To: Marshall, Laura[Laura.Marshall@epa.state.oh.us]
Cc: Brett Fishwild[Brett.Fishwild@CH2M.com]
From: Patterson, Leslie
Sent: Thur 3/14/2013 3:16:34 PM
Subject: RE: SDDL Phase 1A outline comments

From: Patterson, Leslie [mailto:patterson.leslie@epa.gov]
Sent: Tuesday, March 12, 2013 4:13 PM
To: Loney, Adam
Cc: Brett Fishwild; Bryan Heath; James Campbell; Ken Brown; Laura Marshall; Paul Jack; Chan, Valerie; Quigley, Steve
Subject: SDDL Phase 1A outline comments

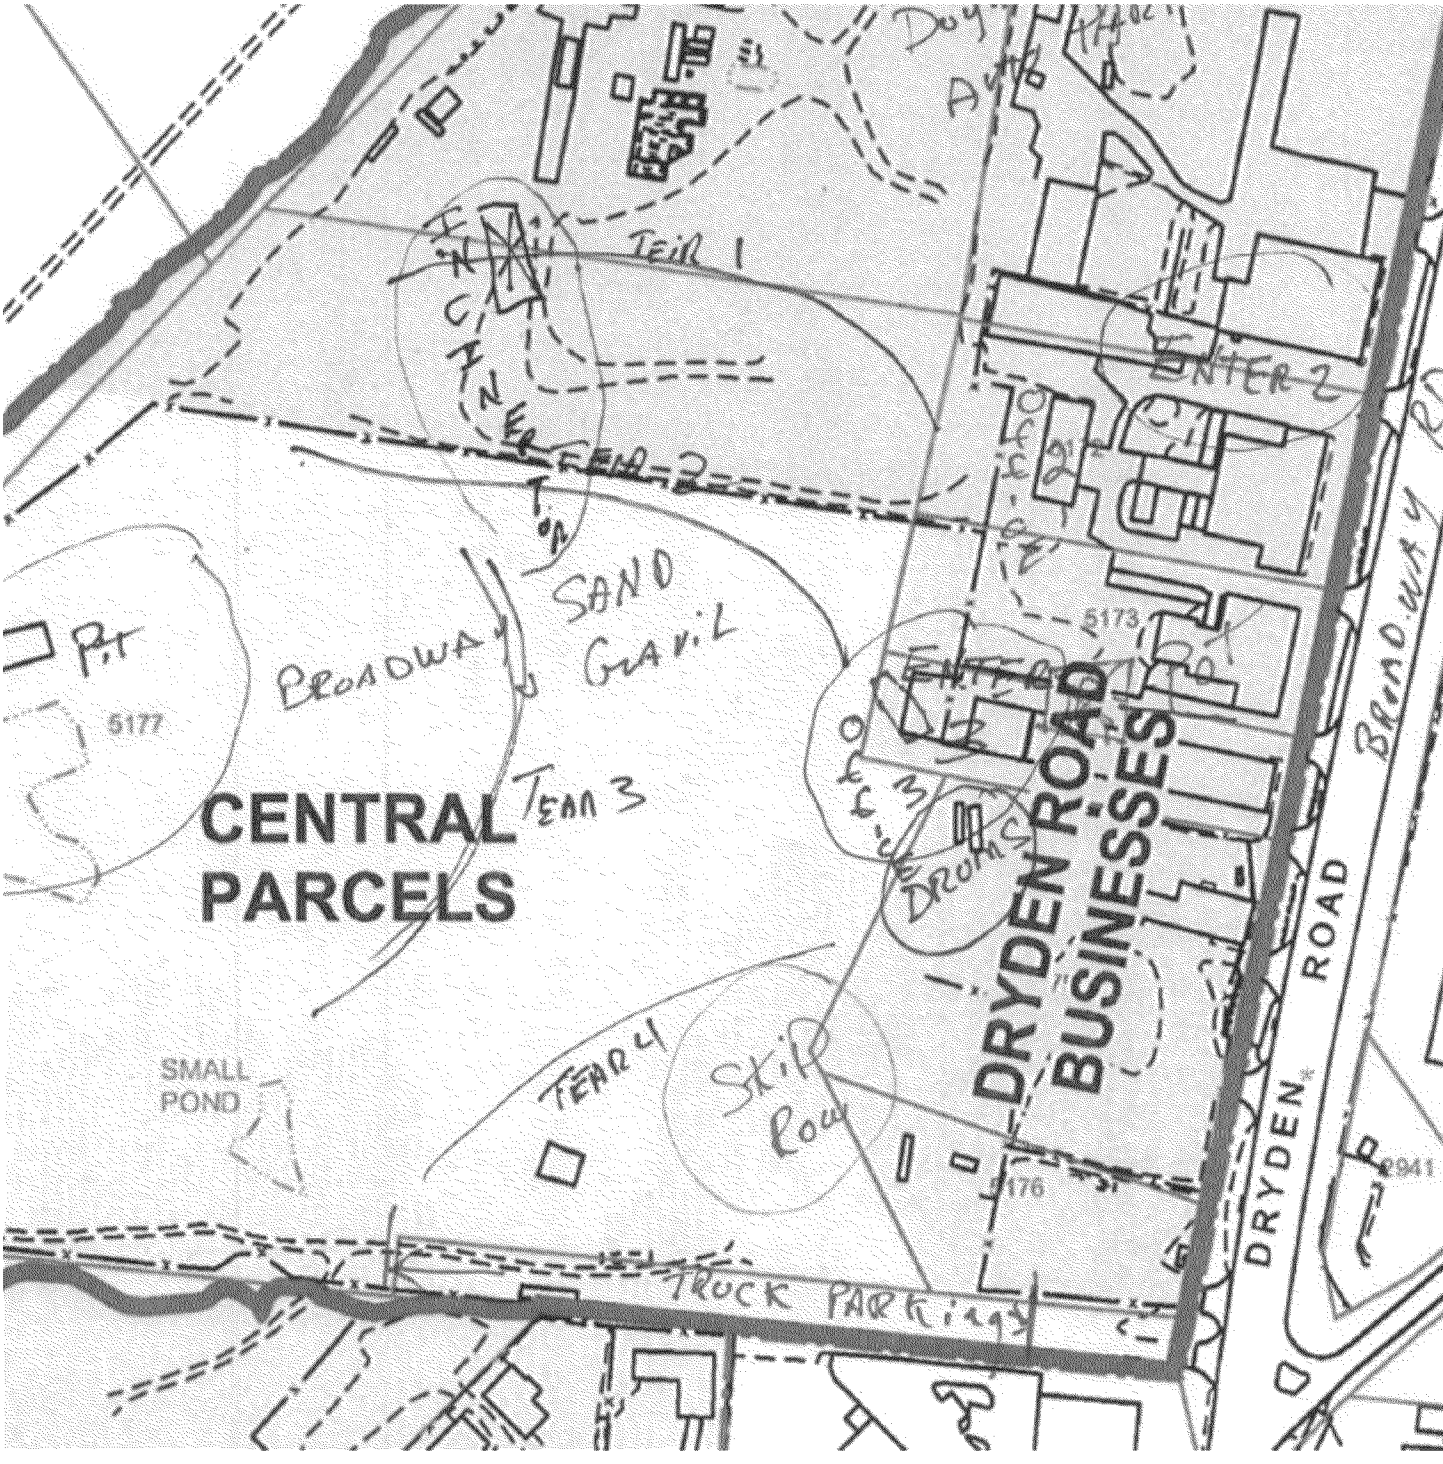
Sure, here's the portion of the Grillot deposition Exhibit 2 that shows drums south of the Entrance 3 office. The transcription of the deposition talks about drums dumped "behind" entrance 3 though, so where that might have happened in relation to the office is a bit unclear. The area of concern would be the area around the office down to the area marked "drums".
